Dolby Laboratories Inc

Field Bulletin 222

CP65 with DA20

Incorrect Wake-up Format after Power-up

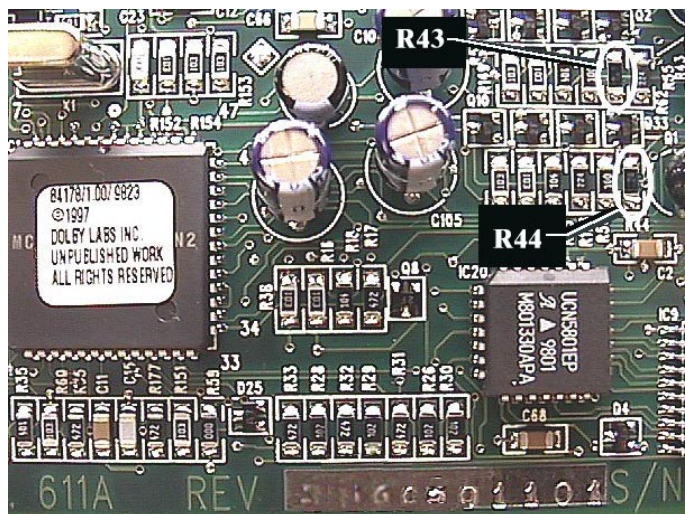
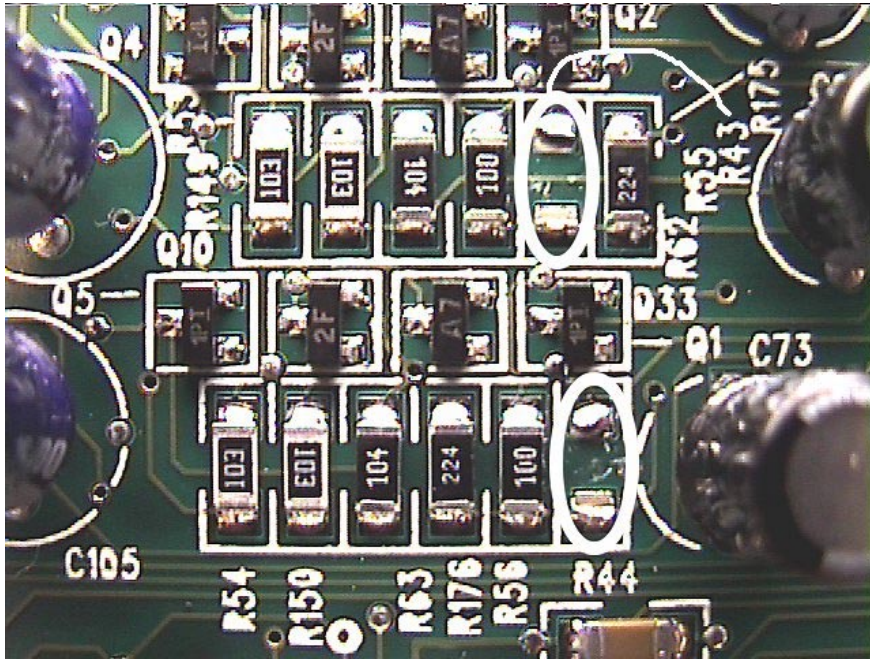
A section of the Cat. No. 611A circuit in the DA20 does not stabilize until **after** the wake-up pulse from the CP65 is received. This causes the Cat. No. 611A to issue an arbitrary format 04 or 05 pulse.

Remove two resistors, which will disable the circuit without affecting DA20 functions. The circuit causing the erroneous pulse is not necessary for proper DA20 operation.

1. Shut off the power to the DA20.
2. Remove the 12 front panel mounting screws.
3. Remove the Cat. No. 611A card from the last right-hand slot.
4. Referring to the figures below, locate resistors R43 and R44.

- Using a small sharp-pointed cutter located at the center portion of the resistor body, shatter each resistor. The resistors should break away cleanly and leave no connections. **Use care to prevent the cutter's sharp tips from damaging any traces on the board beneath the resistors.**

Do not use a soldering iron. A hot soldering iron can damage the surrounding surface-mounted components or PC board traces.

- Reinstall the Cat. No. 611A in the DA20.
- Replace the front panel and the 12 mounting screws.
- Confirm proper wake-up format operation.
